RE: Emergency Administrative Order
Notice of Violation and Addendum
Docket No. SDWA-08-2010-0013
Birney Water System, 083090062
Muddy Cluster Water System,
083090065

Well Pump Failures

Birney Treatment Plant Schematic

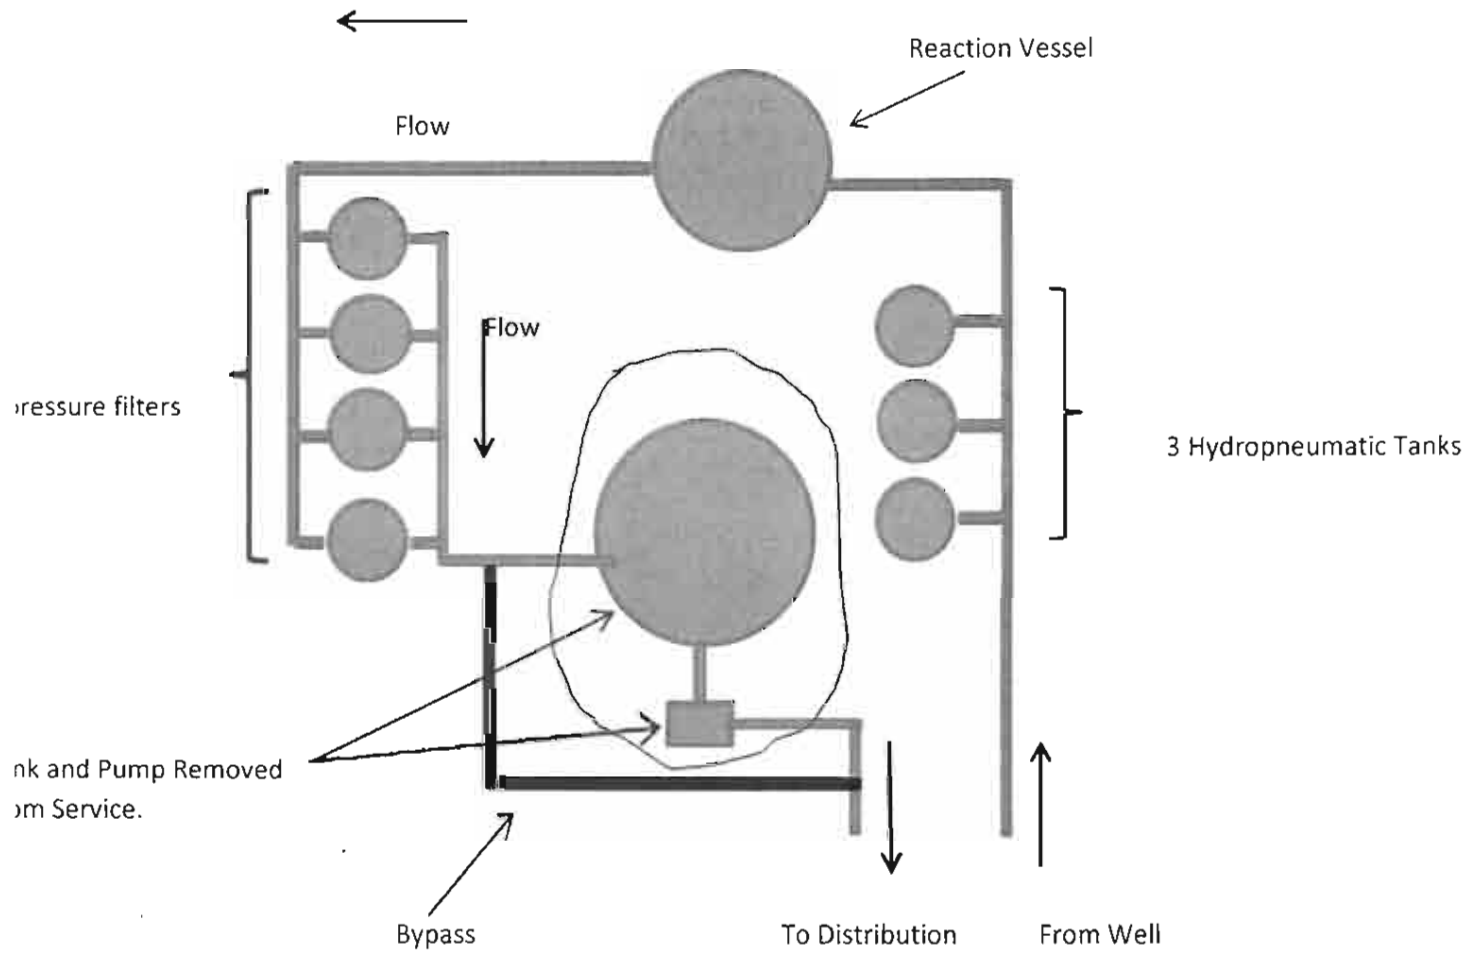
Since initial construction the flow scheme has been altered. The storage tank and the booster pump were removed. A bypass was installed that allowed the well pump to discharge water through the treatment process and into the distribution system. On the above schematic I have circled the items that were removed from service and I have shown the bypass piping in black.

This alteration of the flow scheme has had several undesirable effects:

- 1) A flow restriction results in a rapid pressure build-up once the well turns on. This causes the well to turn off after 30 seconds of run time and to restart approximately 2-1/2 minutes later. This frequent cycling caused the previous well pump to fail after 5 months of service. The cause of this flow restriction is presently unknown and is discussed in further detail later in this report.

- 2) The flow restriction has reduced production through the plant to 6 gallons per minute. This production rate is insufficient to supply the demand from the community.

- 3) The elimination of the booster pump and the Mercoid switch has resulted in no level control for the elevated storage tanks. Recently installed telemetry, which was intended to supply this level control, is inoperable and the operators report that it has not functioned since installation.

- 4) The chemical metering pump for the sodium hypochlorite disinfection system operates continually, even when the well shuts down. This results in over-feeding of chlorine. This overdosing is not acute under the present flow conditions where the well runs for 30 seconds every three minutes, but once the plant is operating correctly severe overfeeding of chlorine will occur.

5) The storage tank and booster pump should be placed back into service at the Birney plant. This will result in a better control scheme for the plant and lower operating pressures.

6) The tank level radio telemetry at Birney should be made operable. This is a new system that was installed in September of 2009. The Indian Health Service should have their vendor affect the needed repairs before the one-year warranty period expires. If the telemetry cannot be made to function correctly and reliably, the Mercoid switch control should be placed back into service.
